ADDENDUM NO. 1

May 31, 2023

Noblesville Ambulatory Surgery Center
14065 Borg Warner Drive
Noblesville, IN 46060

A-M2.01B

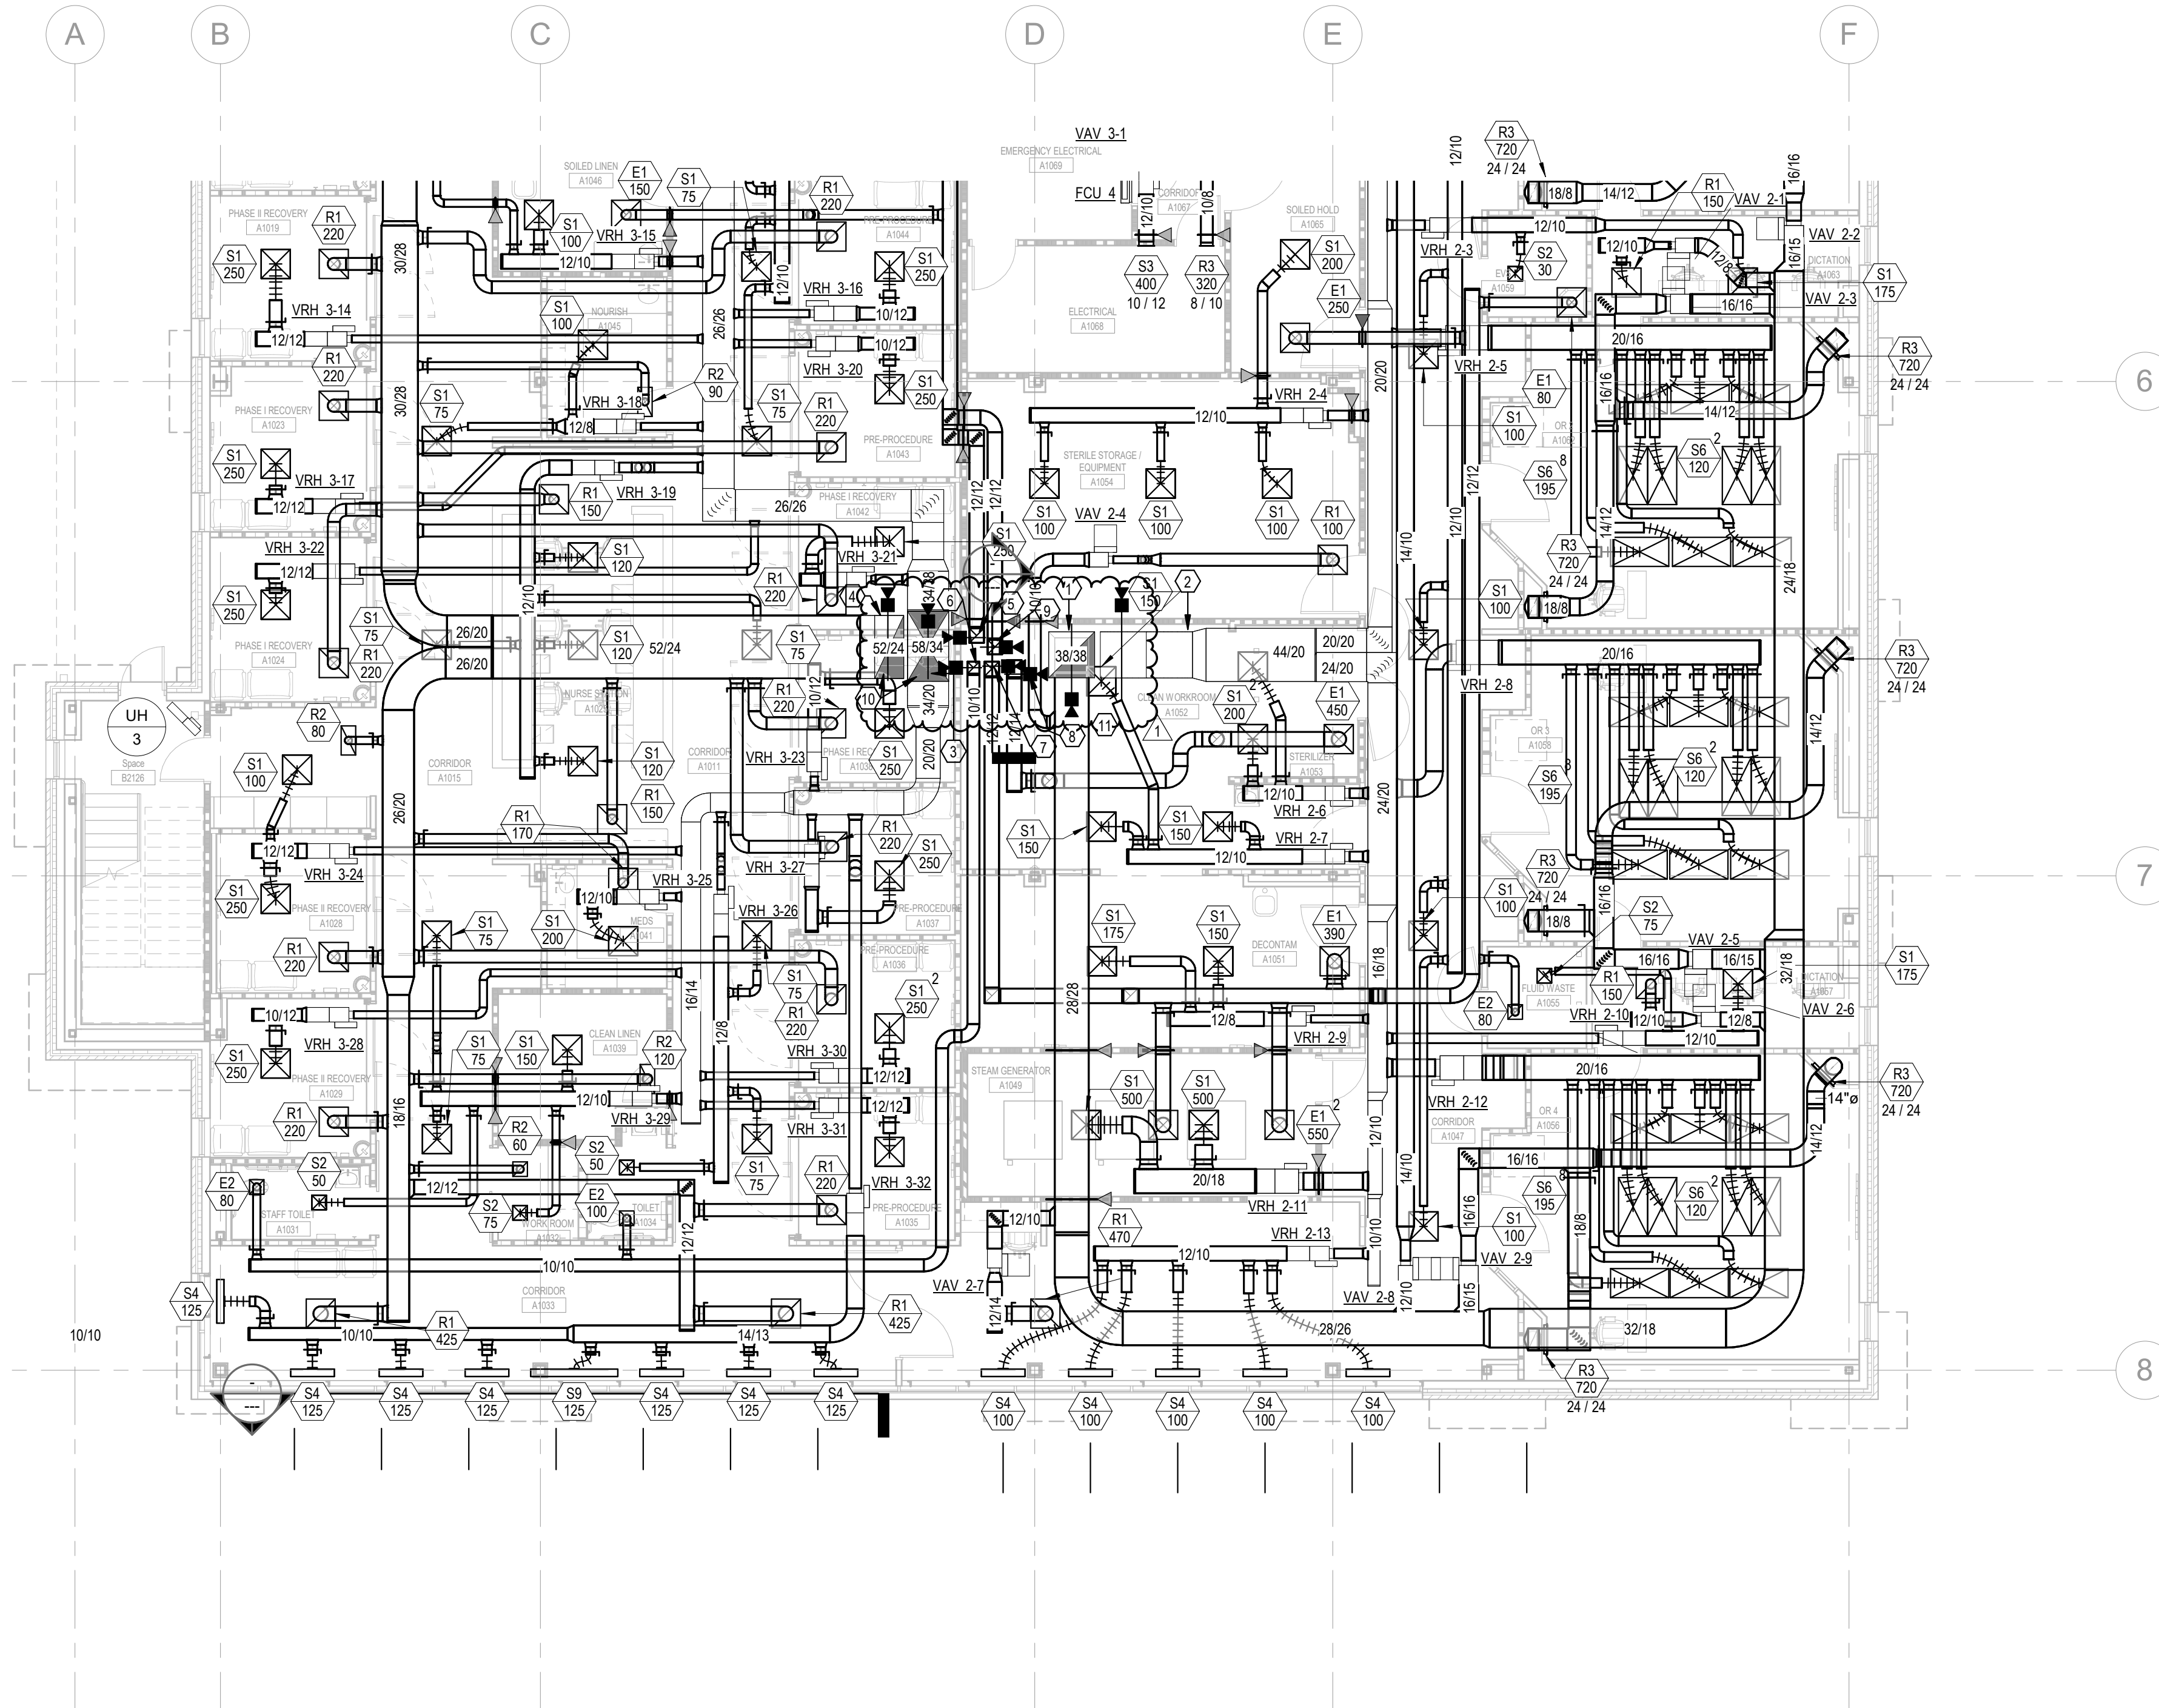
- Added a slot diffuser to VRH 1-6 and modified the associated ductwork.
- Modified ductwork as shown.
